## MEMORANDUM

RE: **Site Source Control (SSC) Work Plan Addendum No. 7  
Proposed Termination of the SSC Sampling Program  
GM Powertrain Bedford Facility  
Bedford, Indiana**

figure 2.1

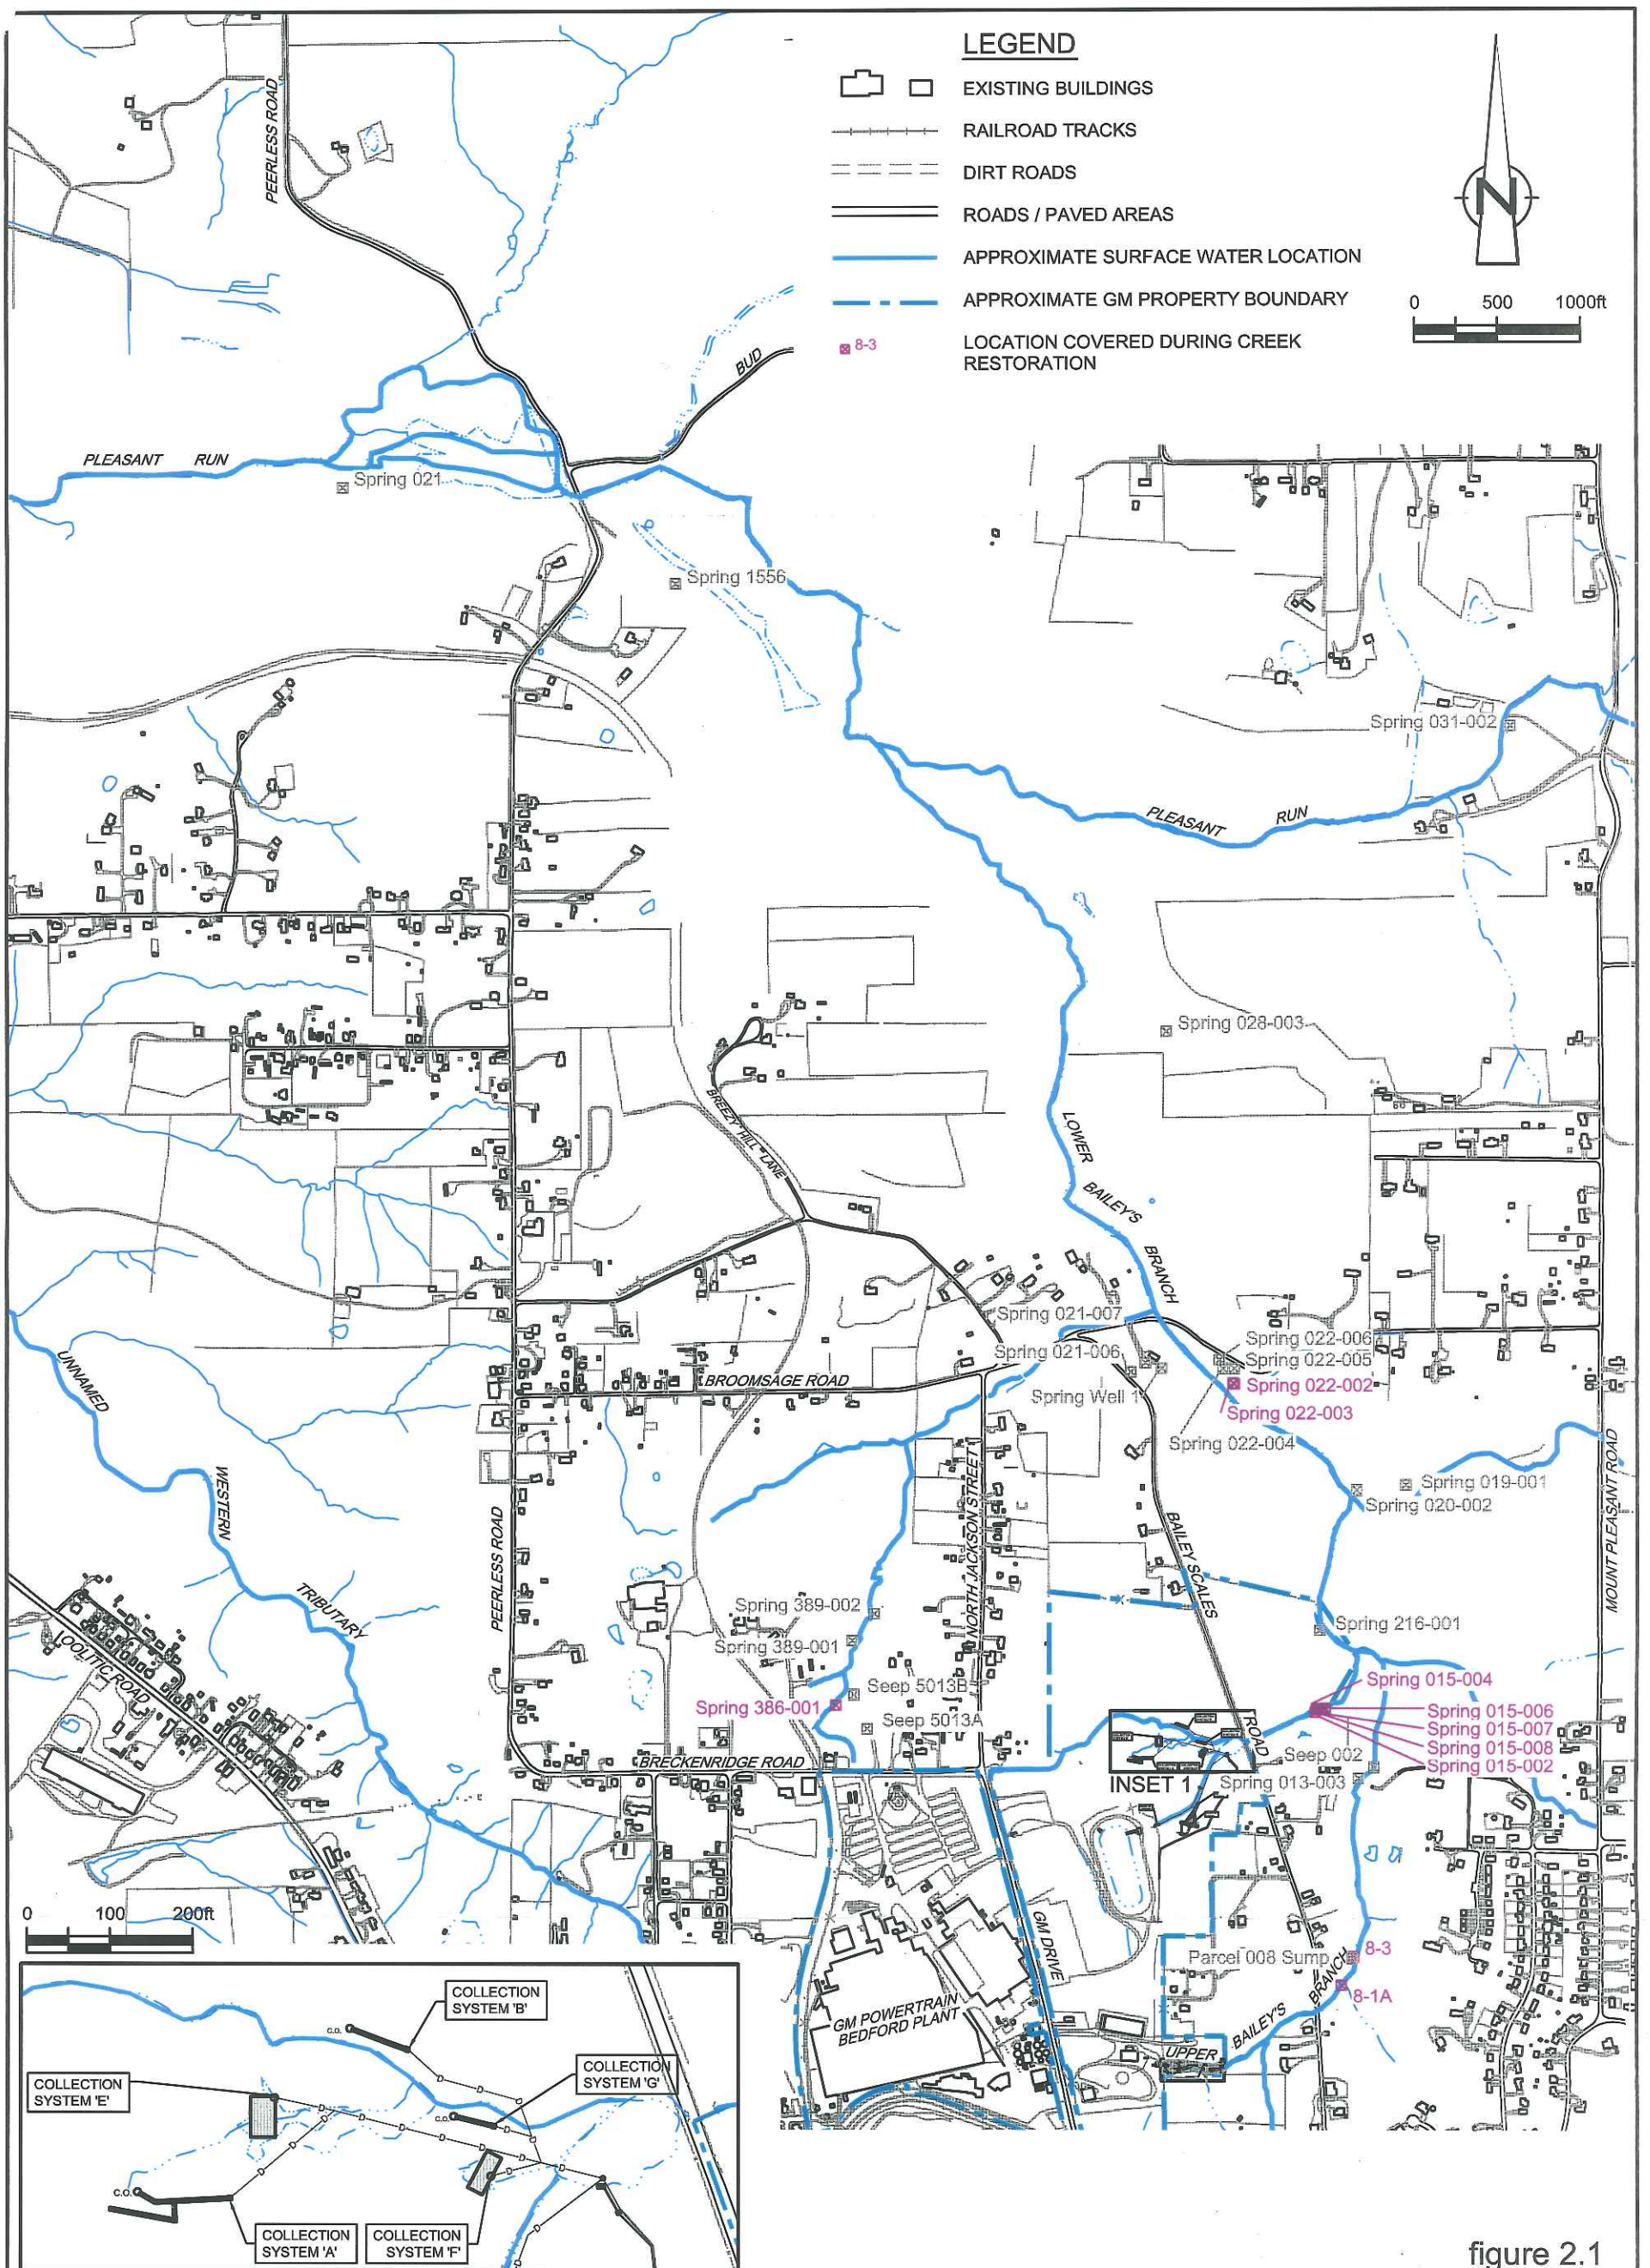
The following ten seep and spring locations were only noted after rain during the time that RA activities were occurring. These locations have subsequently been covered during creek restoration activities and a current seep and/or spring has not been observed since the completion of the creek restoration. Therefore, the following locations cannot be sampled, and are proposed to be removed from the Monitoring Program:

- 8-1A
- 8-3
- Spring 015-002
- Spring 015-004
- Spring 015-006
- Spring 015-007
- Spring 015-008
- Spring 022-002
- Spring 022-003
- Spring 386-001

Figure 2.1 presents the location of seeps/springs covered during creek restoration activities.

figure 2.2

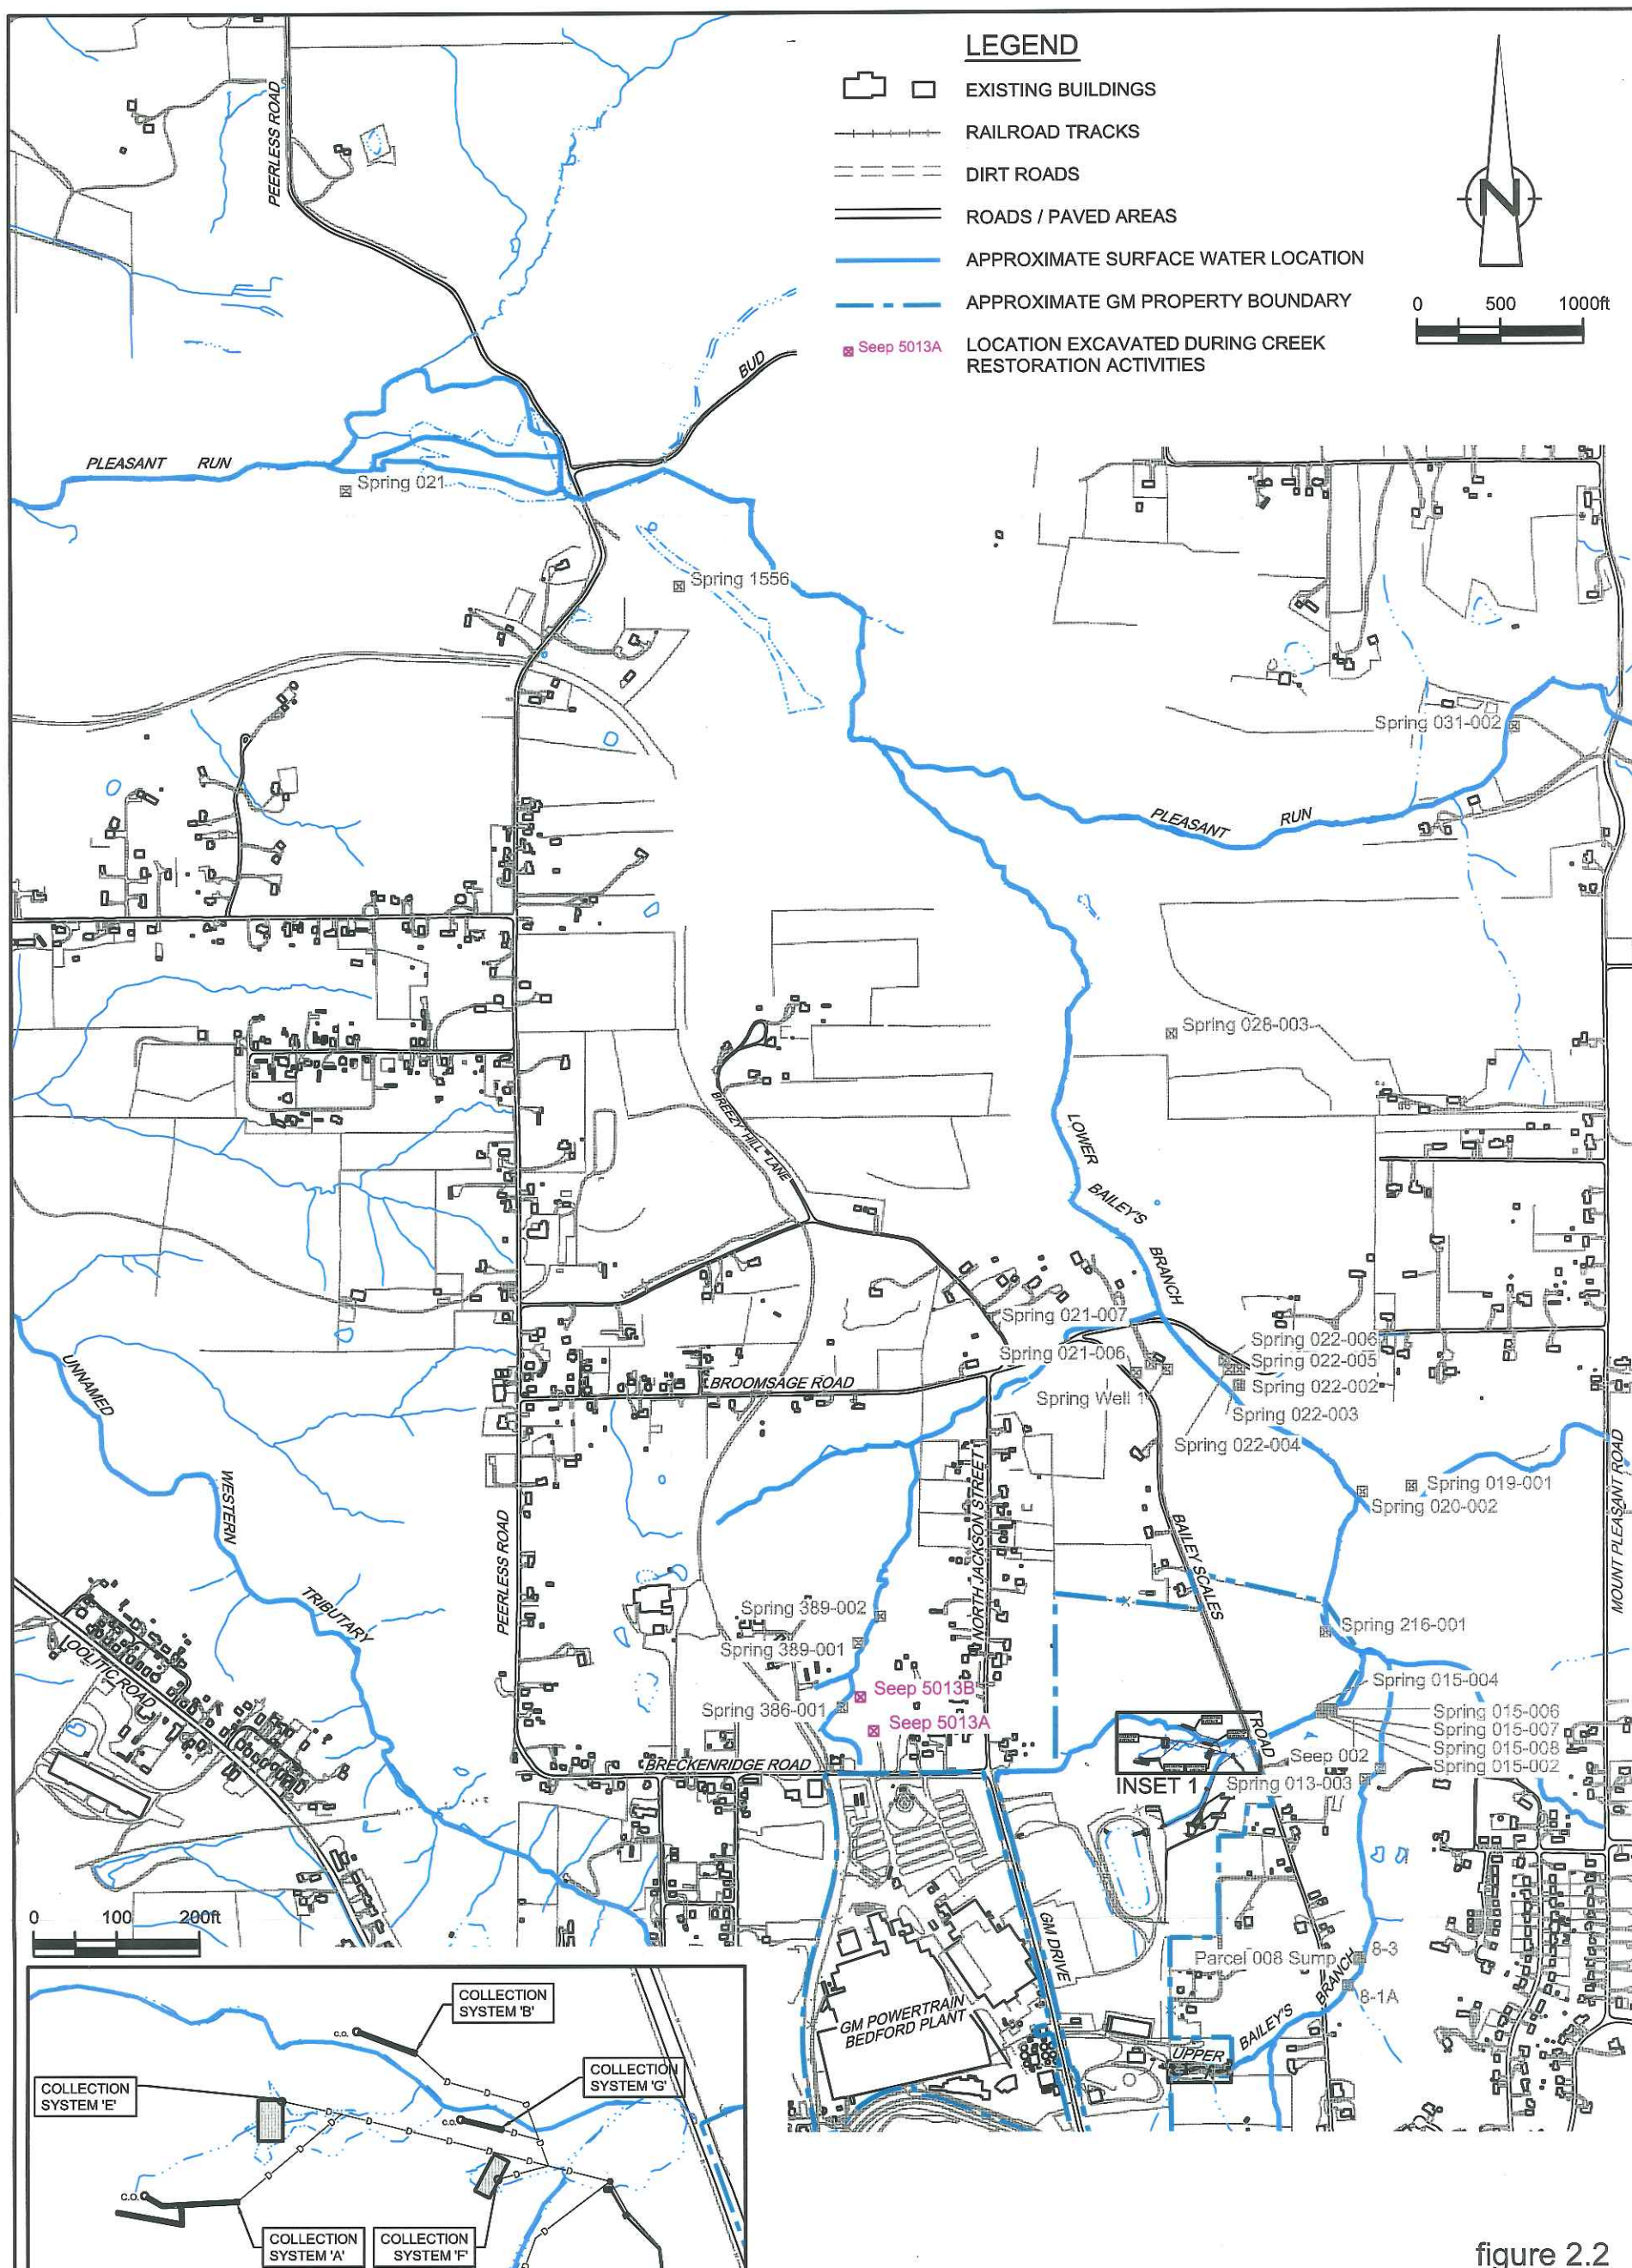
The following two seep and spring locations were only noted after rain prior to the time that RA activities were conducted. These locations have subsequently been excavated during creek restoration activities and a current seep and/or spring has not been observed since the completion of the creek restoration. Therefore, the following locations no longer exhibit discharges and cannot be sampled, thus they are proposed to be removed from the Monitoring Program:

- Seep 5013A
- Seep 5013B

Figure 2.2 presents the location of seeps/springs excavated during creek restoration activities.
